This Amendment is submitted in response to the Office Action mailed May 10, 2005. In the Office Action, the Examiner has acknowledged Applicant's election without traverse of Group 1 (claims 1-21), Species C (claims 10-13), and has withdrawn claims 8, 9, and 22-35 from further consideration pursuant to 37 CFR 1.142(b) as being drawn to a nonelected invention and species. Also in the Office Action, the Drawings, Specification, and Claims were objected to for various informalities, Claims 1-4, 10 and 16-19 were rejected as being anticipated by US Patent No. 3,752,474 to Macabet et al. ("Macabet"), Claims 1 and 21 were rejected as being anticipated by US Patent No. 5,433,688 to Davies ("Davies"), Claim 20 was rejected as being unpatentable over Macabet in view of US Patent No. 6,258,011 B1 to Wolfe ("Wolfe"), Claims 14 and 15 was rejected as being unpatentable over Macabet in view of US Patent No. 4,060,240 to Dunston ("Dunston"), Claims 1-7, 16, 18, and 19 were rejected as being unpatentable over US Patent No. 5,352,172 to Suzuki ("Suzaki") in view of US Patent No. 5,217,029 to Shields ("Shields"), and Claims 1 and 10-13 were rejected as being unpatentable over BODYBUILDER'S DISCOUNT

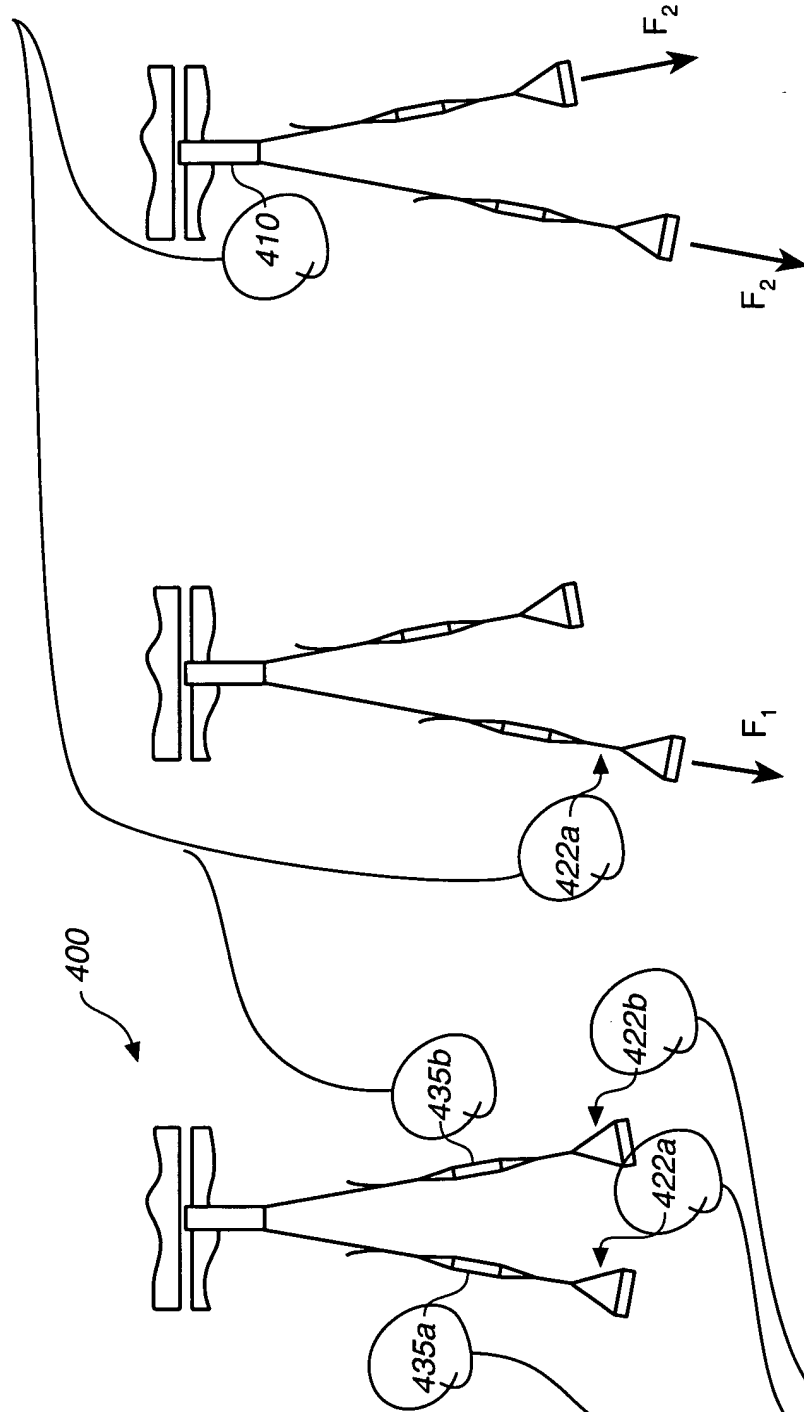
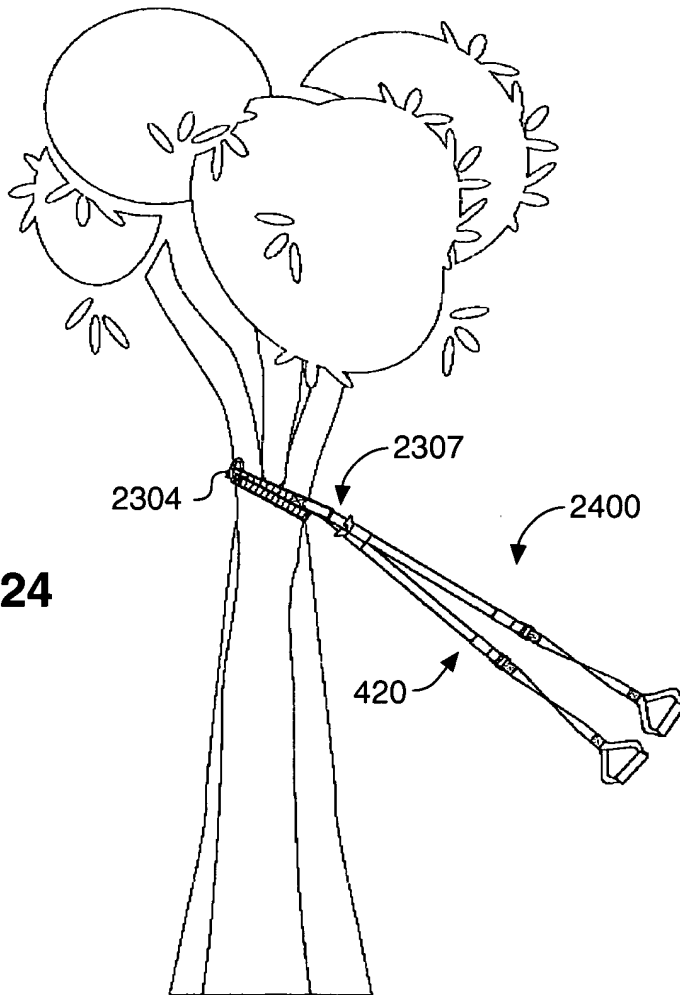
Replacement Sheet 8, which includes FIGS. 12A, 12B, 12C, and 12D, has been amended to include reference numerals 422a, 422b, and 435a in FIGS. 12B and 12C, and Replacement Sheet 10, which includes FIGS 13A, 13B, and 13C, has been amended to include reference numerals 410, 422a, 422b, 435a, and 425b in FIGS. 13A, 13B, and 13C. Changes to Replacement Sheets 8 and 10 in compliance with 37 CFR §1.121(d) and are indicated in the attached Annotated Sheet Showing

3) Changes to FIG. 12B and 12C in Replacement Sheet 8. This sheet, which includes FIG. 12A, 12B, 12C, and 12D, replaces the original sheet including FIG. 12A, 12B, 12C, and 12D. In Figures 12B and 12C reference numerals 422a, 422b, and 435a have been added as noted in the attached Annotated Sheet Showing Changes.

Reference  
numerals  
added

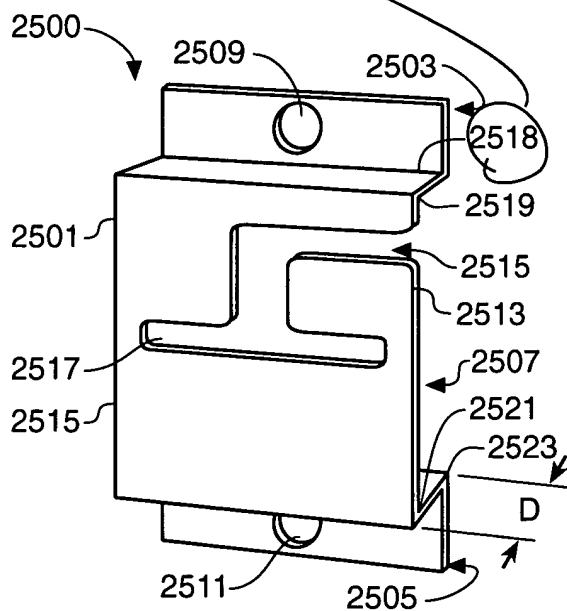
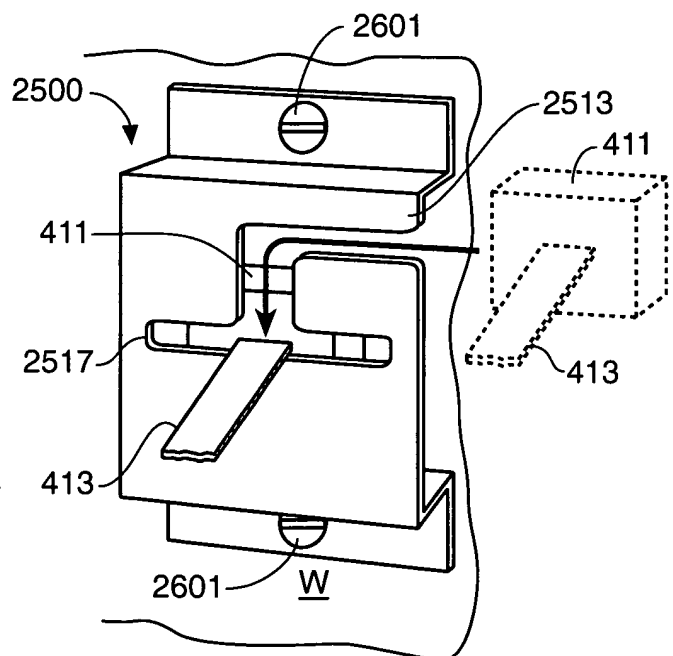
4) Changes to FIG. 13A, 13B, and 13C in Replacement Sheet 10. This sheet, which includes FIG. 13A, 13B, and 13C, replaces the original sheet including FIG. 13A, 13B, and 13C. In Figures 13A, 13B, and 13C reference numerals 410, 422a, 422b, 435a, and 425b have been added as noted in the attached Annotated Sheet Showing Changes.

Reference  
numerals  
added

Reference  
numerals  
added
